Community Clubs

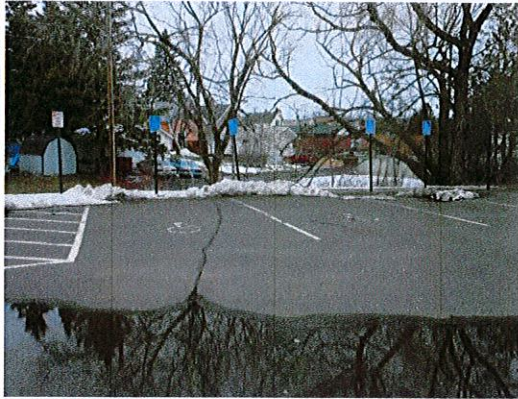
Photo 1: View of accessible parking. Restripe the accessible parking to provide 8' wide aisles (can be shared between 2 spaces).

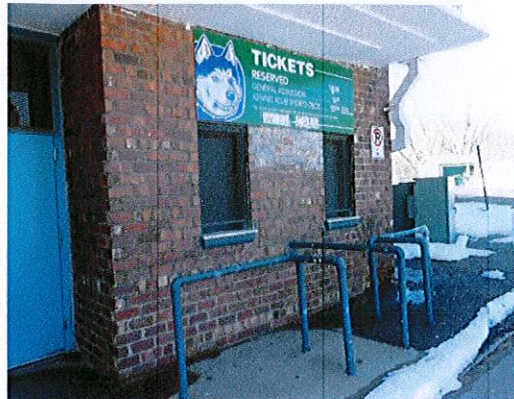
Photo 2: Modify the ticket windows (lower to 36", currently at 43") and modify (or remove) the crowd control railings to provide a 36" wide route (currently 21").

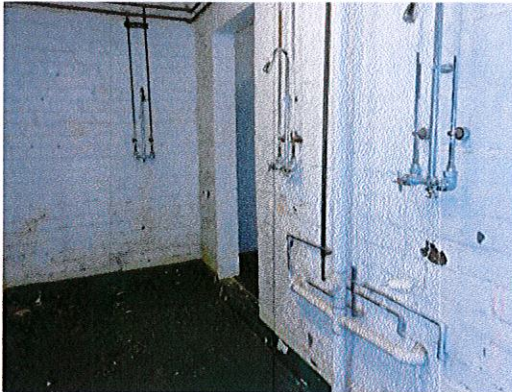
Photo 10: The visitor clubhouse currently provides no features of accessibility.
